HISTORIC AND DESIGN REVIEW COMMISSION

January 17, 2018

HDRC CASE NO: 2018-011
ADDRESS: 504 KING WILLIAM
LEGAL DESCRIPTION: NCB 749 BLK 8 LOT 9,10, NW IRR 28.2FT OF 1 & NW 61.2 FT OF 2
ZONING: RM-4, HS
CITY COUNCIL DIST.: 1
DISTRICT: King William Historic District
LANDMARK: Steves, Albert - House
APPLICANT: Jim Poteet, FAIA/Poteet Architects, LP
OWNER: Laurel Heights Family Irrevocable Trust
TYPE OF WORK: Exterior modifications, guardrail installation
APPLICATION RECEIVED: December 21, 2017
60-DAY REVIEW: February 19, 2018
REQUEST:

1. Construct a 2'-0" deep bay addition along a portion of the north east façade of a previously enclosed porch.
2. Add a painted steel guardrail to the roof deck above the enclosed porch.

ELEVATION: PROPOSED ALTERATIONS

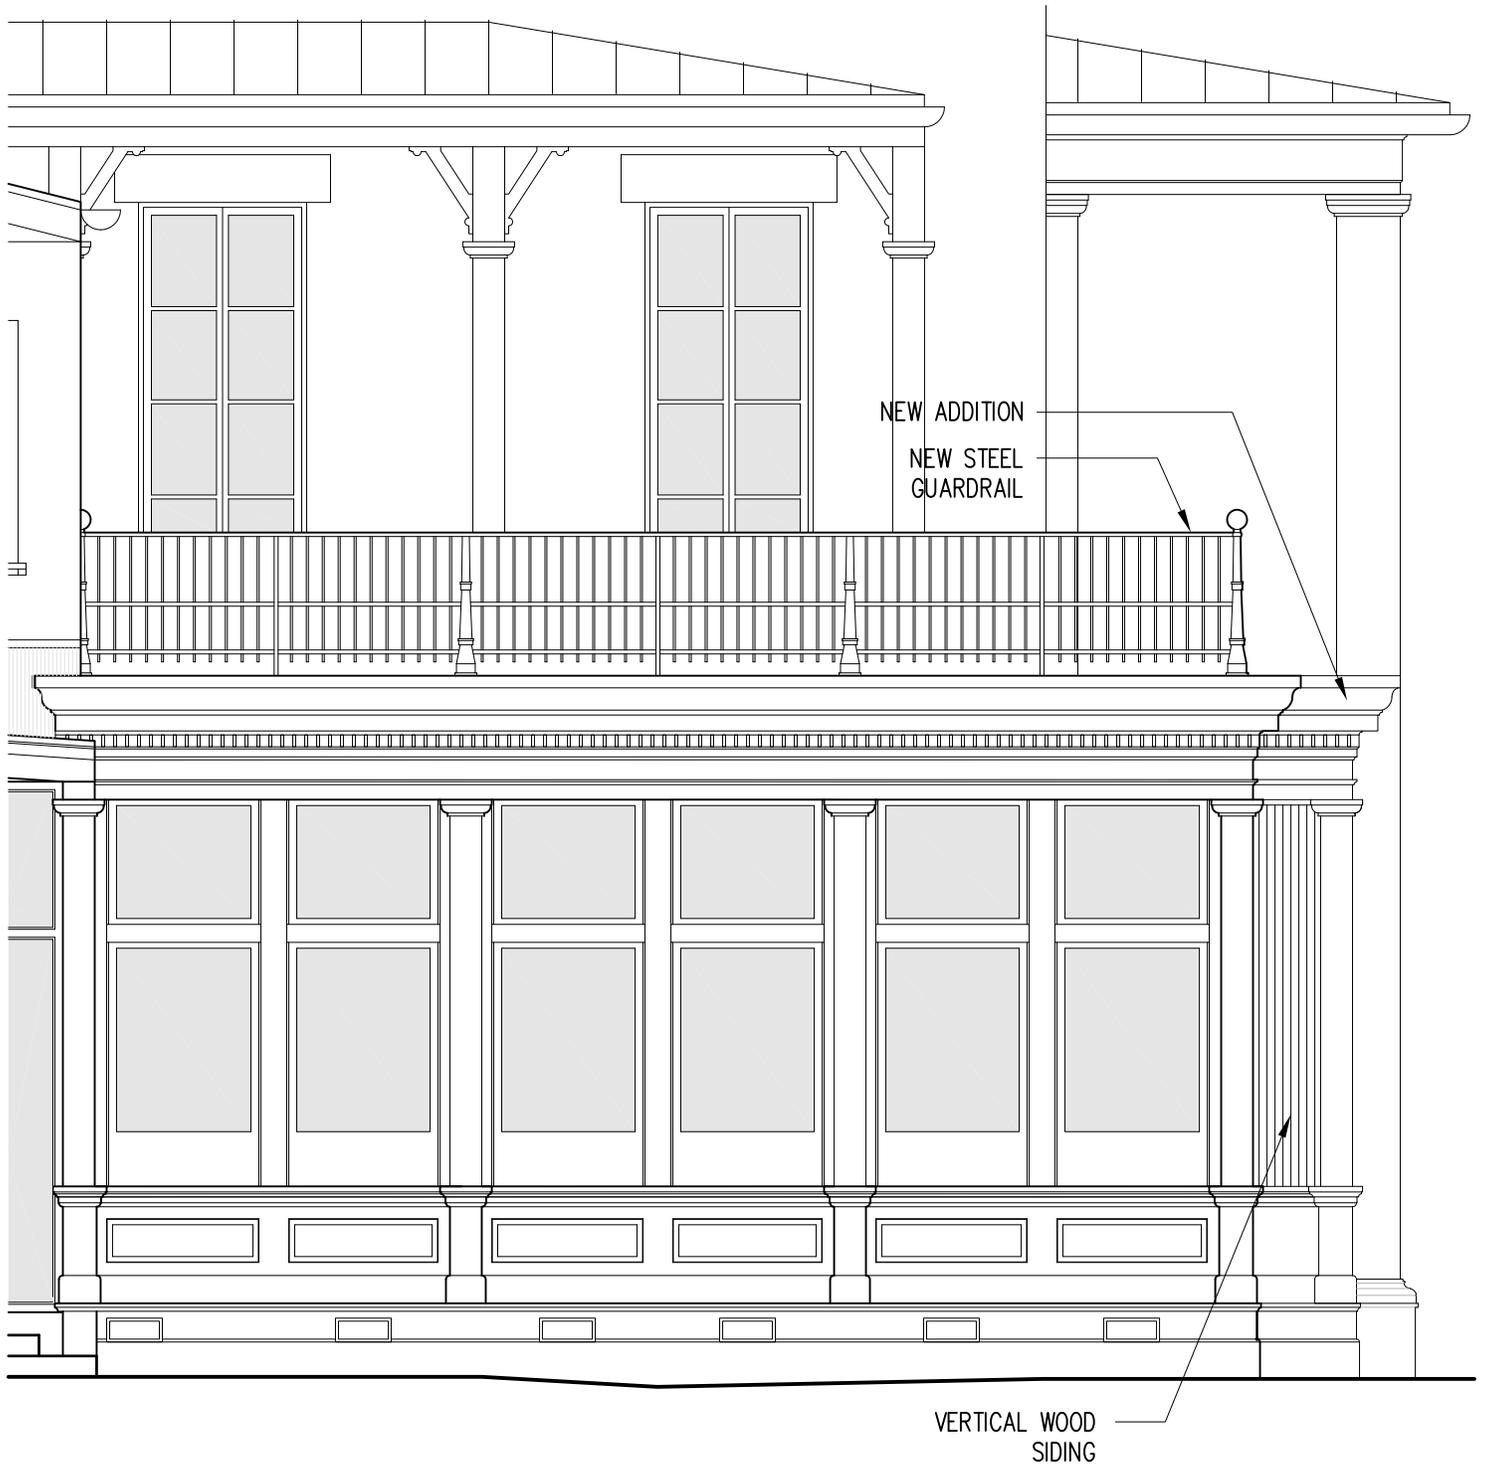
- b. BAY ADDITION – On an existing rear addition, the applicant has proposed to construct a 2’ – 0” deep bay along the north east façade. The applicant has proposed for the addition to feature an overall width that is less than that of the original addition to provide a visual separation. Regarding materials, the applicant has proposed to use wood siding and wood elements to match those of the existing addition. The roof will feature a sheet metal cap and a profile to match the existing. Staff finds the proposed bay addition appropriate.

Staff recommends approval of items #1 and #2 as submitted based on findings b and c.

1 **DTL:** STEEL GUARDRAIL
SCALE: 1" = 1'-0"

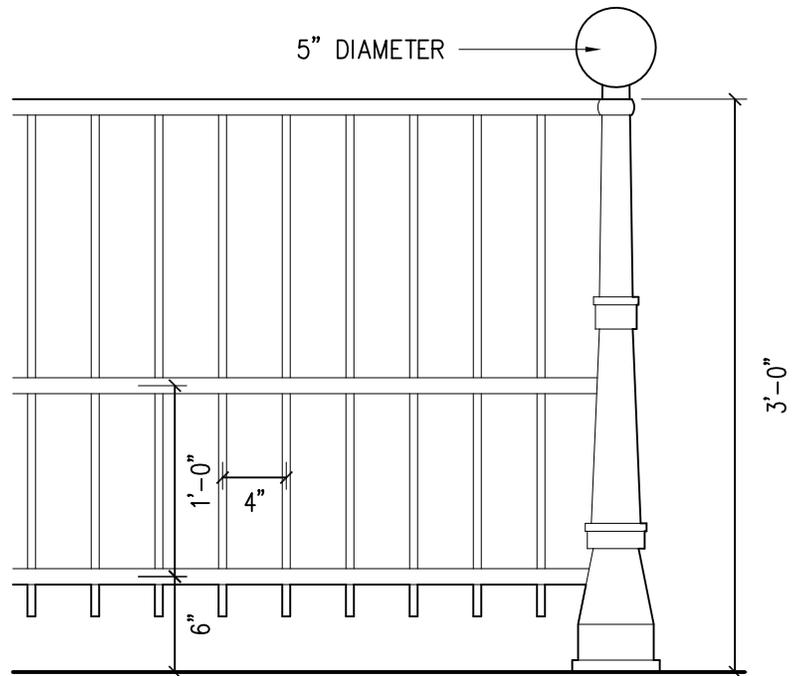
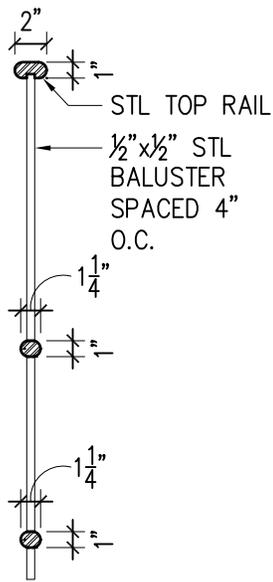
- c. GUARDRAIL ADDITION – Atop of the existing addition, the applicant has proposed to install a steel guardrail to provide access to the rooftop. The design and profile of the proposed steel guardrail is architecturally consistent with other metal ornamentation of the historic structure. Staff finds this installation appropriate.
